RESPONSE TO REQUEST FOR ADDITIONAL INFORMATION

APR1400 Design Certification

RAI No.: 469-8578

SRP Section: 09.01.01 - Criticality Safety of Fresh and Spent Fuel Storage and Handling

Figure 1 Schematic diagram for distortion of fuel storage cell

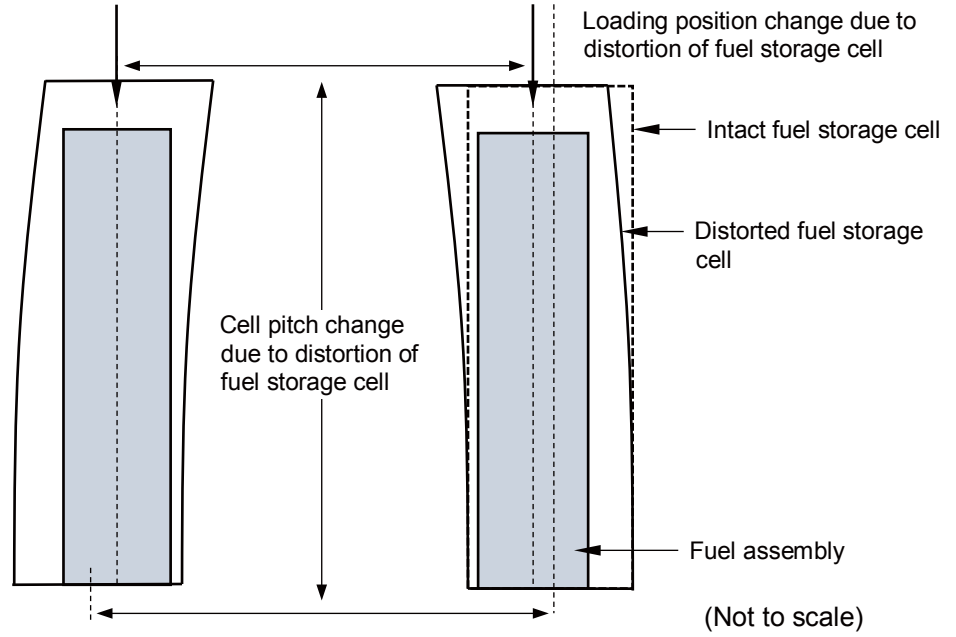
How does the criticality evaluation account for fuel storage cells that are not straight?

The fuel storage cells that are not straight can impact the cell pitches and fuel assembly loading positions as shown in Figure 1. The effects of the cell pitches and fuel assembly loading positions in the criticality analysis were evaluated and included in the total uncertainty as follows.
